VIGIL AAD

SERVICE BULLETIN #2

Date : 18th April 2006
Subject : Damages Stated on the Plastic Loop Protection Heads of the Cutter
Status : Replacement of damaged cutters and loops
Identification : Any reserve parachute of which the cutter is located above the pilot chute and which has been closed by mechanical means to increase traction force or closed with a temporary pin directly placed on the cutter.

Pictures of Service Bulletin # 2 Photos du Bulletin de Service #2

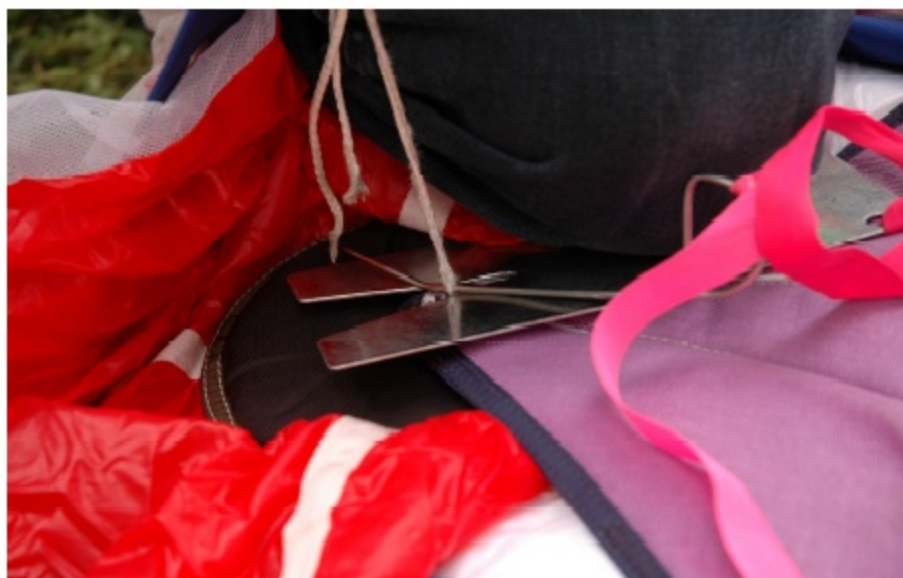
We would like to remind you that it is not allowed to use inadequate mechanical tools (force reduction systems) to close the reserve parachute. Those mechanical systems could implement a too important traction effort (above 10 daN maximum according to the TSO norms) to release the pin of the reserve parachute (see pictures #1, 2& 3 of Russian + South American + European Tools).

The use of an inadequate mechanical system or the wrong placement of a temporary pin can cause the crushing of the cutter against the grommets or the temporary pin during the closing of the reserve (for example: using a temporary pin placed above the pilot chute, then placing the flap with the cutter and start traction on the closing loop with the temporary pin still in place). Those closing techniques could create such forces that the pressure between metallic grommets or pin could damage the plastic protection ring as even the stainless steel cutter body (see picture # 4).

Any damage of these plastic heads could provoke a deterioration of the reserve closing loop by friction during transport or use of the equipment. Those deteriorations could cause an inopportune opening of the reserve container (see picture #5).

A particular attention is requested to look carefully that the small plastic loop protection heads of the cutter(s) are not damaged during the repack of the reserve. If any degradation sign is detected on the plastic loop protectors, it is imperative to replace the cutter unit and the loop to avoid any reserve loop deterioration.
